SUBJECT: PLANS AND PROPOSAL ADDENDUMS PROJECT: F 2023 (629) CONTROL: 0038-05-040 COUNTY: ZAPATA LETTING: 05/05/2023 REFERENCE NO: 0426 PROPOSAL ADDENDUMS PROPOSAL COVER X BID INSERTS (SH. NO.: ALL \_ GENERAL NOTES (SH. NO.: \_ SPEC LIST (SH. NO.: SPECIAL PROVISIONS: ADDED: DELETED: SPECIAL SPECIFICATIONS: ADDED: DELETED: X OTHER: PLAN SHEETS AND OTHER CHANGES DESCRIPTION OF ABOVE CHANGES (INCLUDING PLANS SHEET CHANGES) \*\*\*\*\* BID INSERTS \*\*\*\*\* REVISED QUANTITIES FOR THE FOLLOWING BID ITEMS: 160-6005, 168-6001, 506-6034 BID INSERT SHEETS 1-14 OF 14 CHANGED AS A RESULT OF THE ABOVE REVISIONS. PLANS: \*\*\*\* PLAN SHEETS 15,15A-15D (ESTIMATE & QUANTITY SHEETS) -REVISED SHEETS AS DESCRIBED ABOVE IN THE BID INSERTS OF THE PROPOSAL. PLAN SHEET 41 - REVISED TCP GENERAL NOTES SHEET TO INCLUDE A NOTE ON UTILITY RESTRICTIONS.

**CONTROLLING PROJECT ID** 0038-05-040

US 83 ZAPATA TRAFFIC CONTROL PLAN GENERAL NOTES

SHEET 18 OF 18 HIGHWAY JOB 0038 05 040 US 83 433

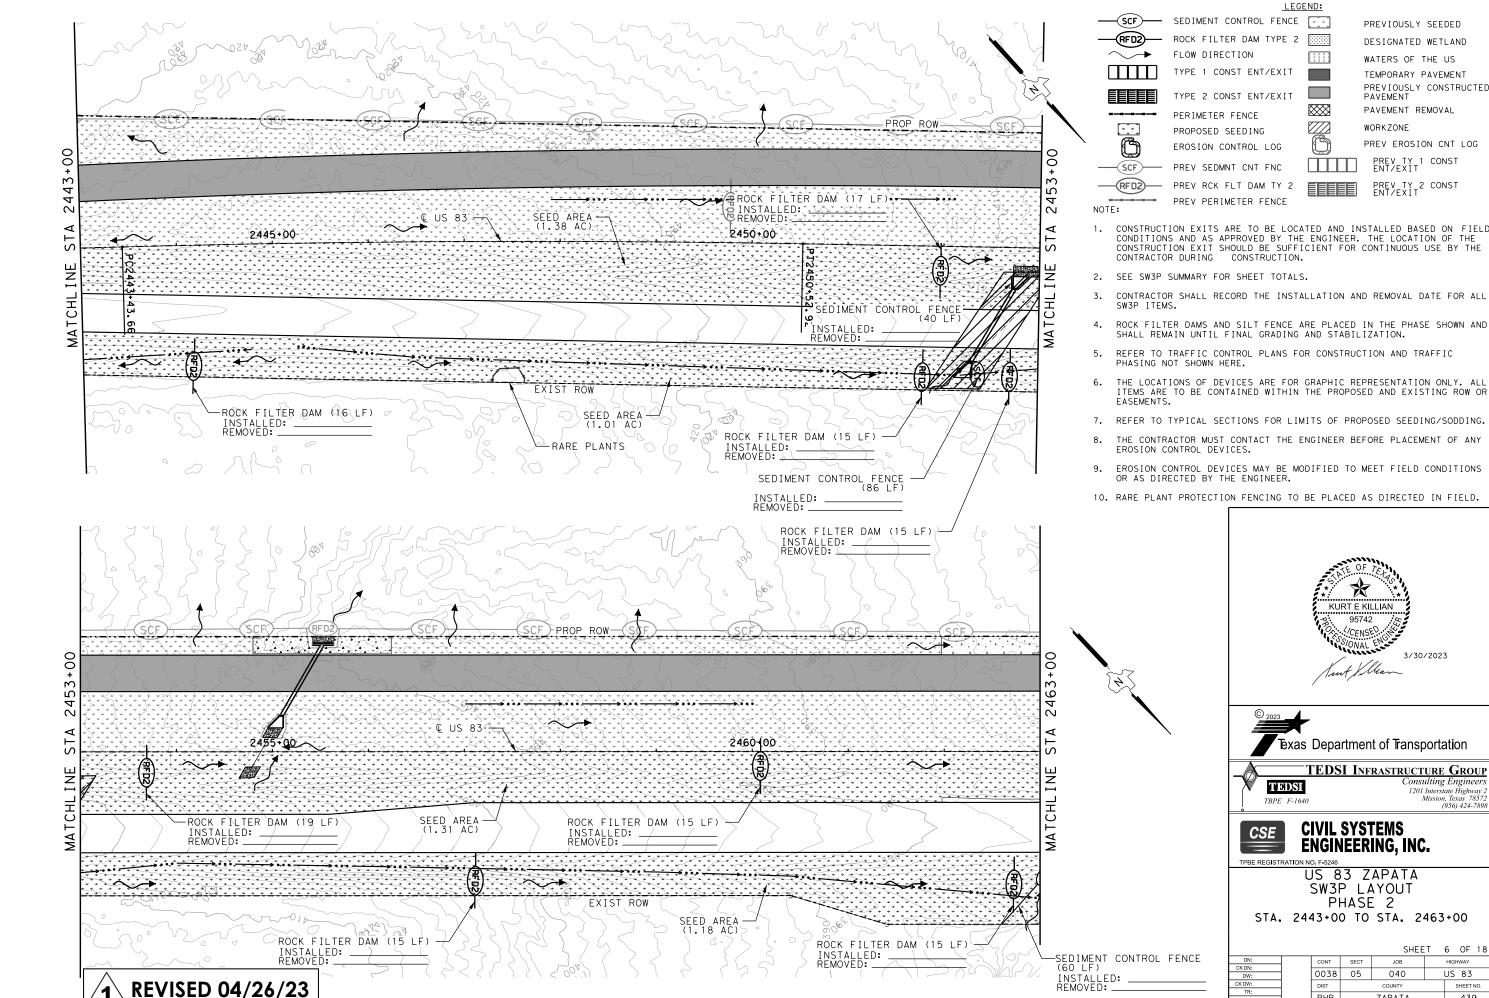
PLAN SHEETS 413,433,439,443,448,449, AND 451 -

REVISED SW3P SHEETS.
